REQUEST FOR INFORMATION	DATE: July 28, 2016	NO.: RFI-223
--------------------------------	----------------------------	---------------------

Project Name:	15051-Webster University Interdisciplinary Science Building	Project No.: 15051
---------------	---	--------------------

Subject: Concrete vertical construction joint location

S0100

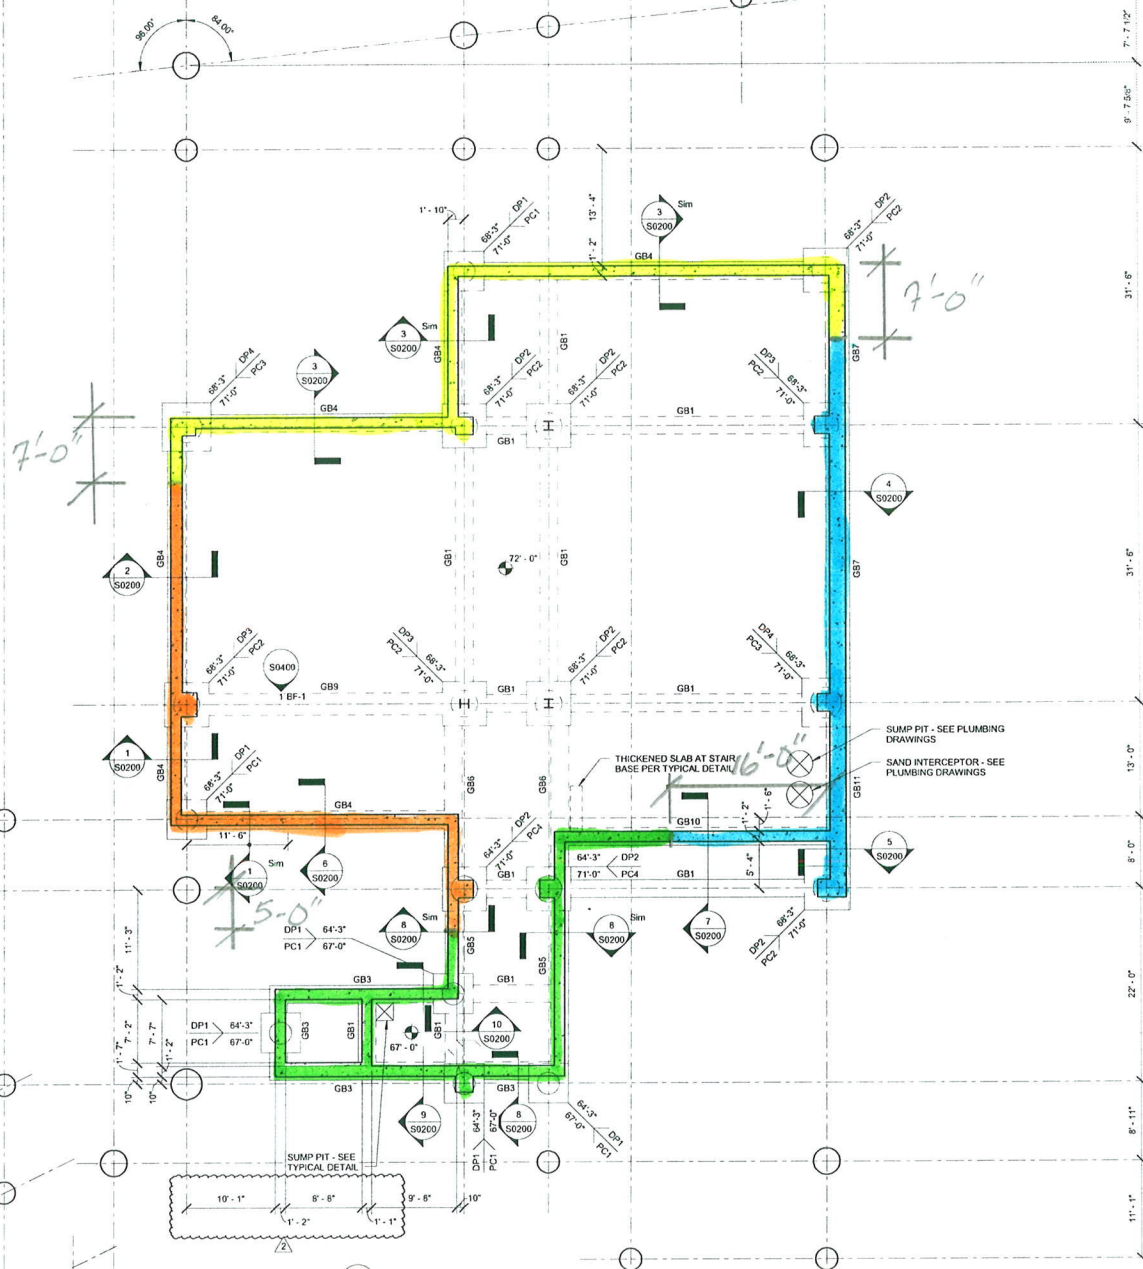
Please find attached a revised pour sequence plan for the concrete foundation walls. Please review and provide the dimension of the vertical construction joint location from the closest column line for the foundation walls on Level 0 and the remaining foundation walls on Level 1. In addition, please review the proposed lineal feet of each pour.

LEVEL 0
FOUNDATION WALLS

SEP 1
SEP 2
SEP 3
SEP 4

ALL CONSTRUCTION JOINTS
SHALL HAVE WATERSTOP
AND SPLICED HORIZONTAL
REINFORCING PER 7/S0002

S0101

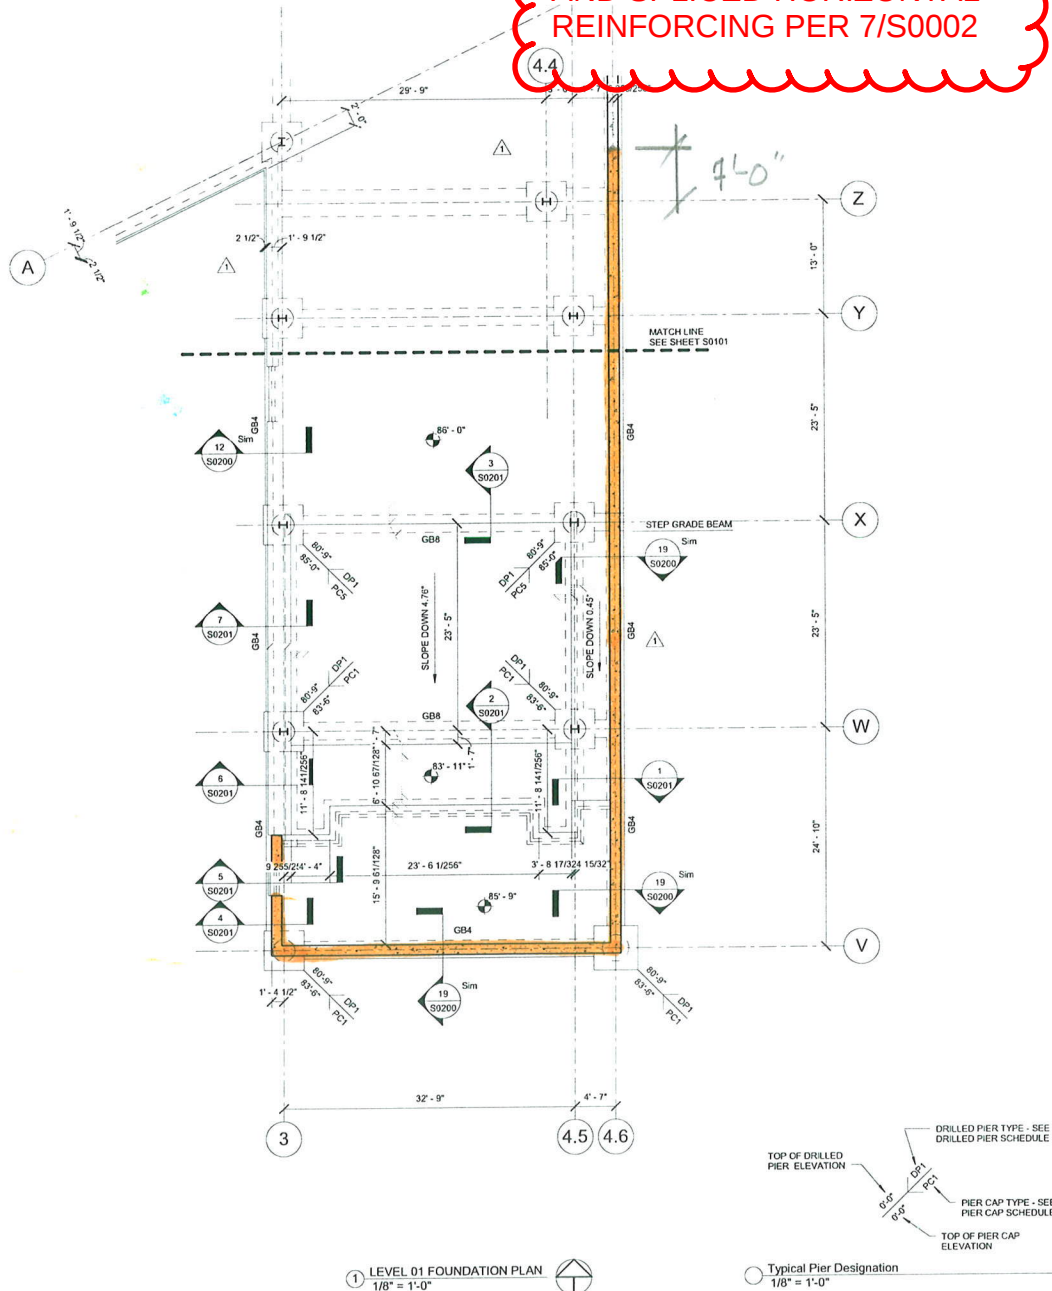
LEVEL 1
FOUNDATION WALLS

SEQ 5
SEQ 6
SEQ 7
SEQ 8

DETAIL TO BE PROVIDED
FOR INTERRUPTED GRADE
BEAM AND WALLS FOR
RAMP - SEE RFI #255
RESPONSE WHICH WILL BE
FORTHCOMING

ALL CONSTRUCTION JOINTS
SHALL HAVE WATERSTOP
AND SPLICED HORIZONTAL
REINFORCING PER 7/S0002

S0102

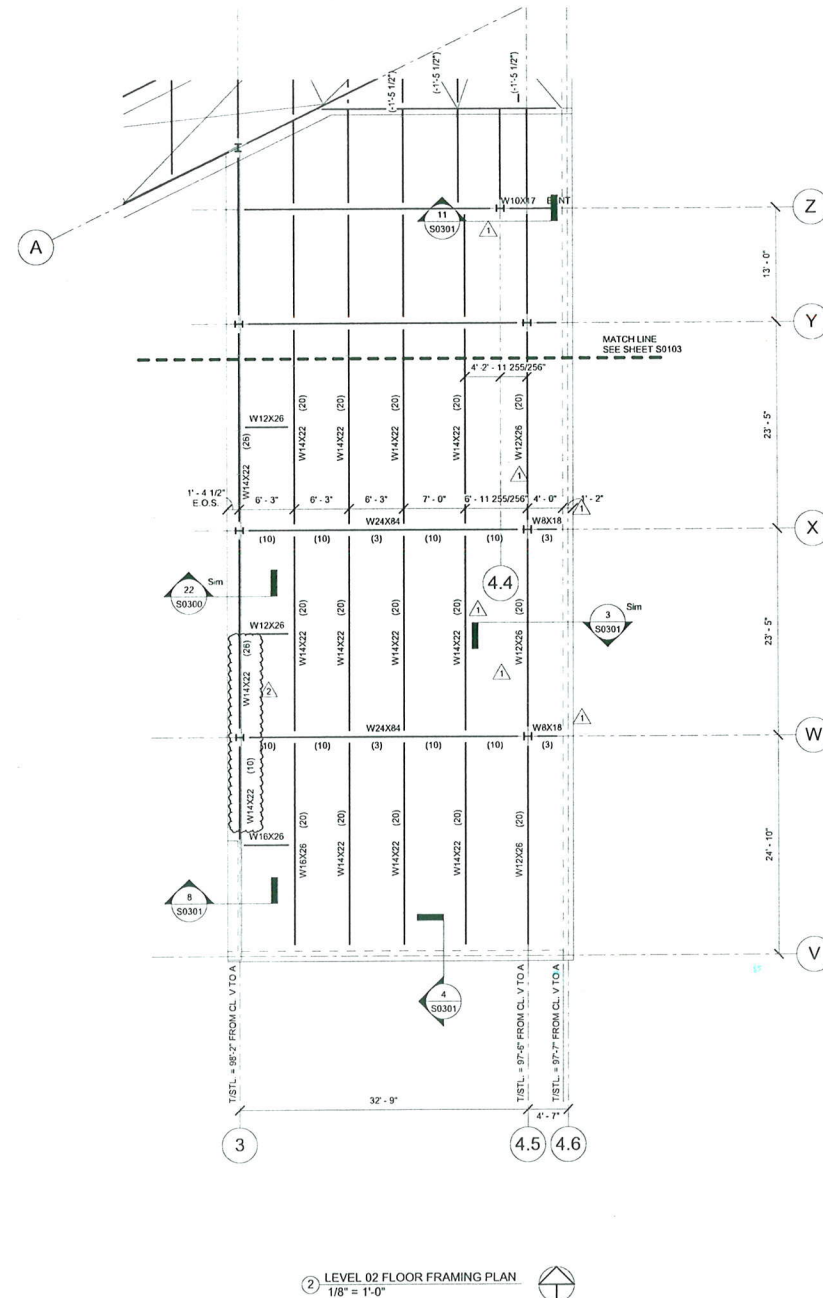
LEVEL 1 FOUNDATION WALLS

ALL CONSTRUCTION JOINTS SHALL HAVE WATERSTOP AND SPLICED HORIZONTAL REINFORCING PER 7/S0002
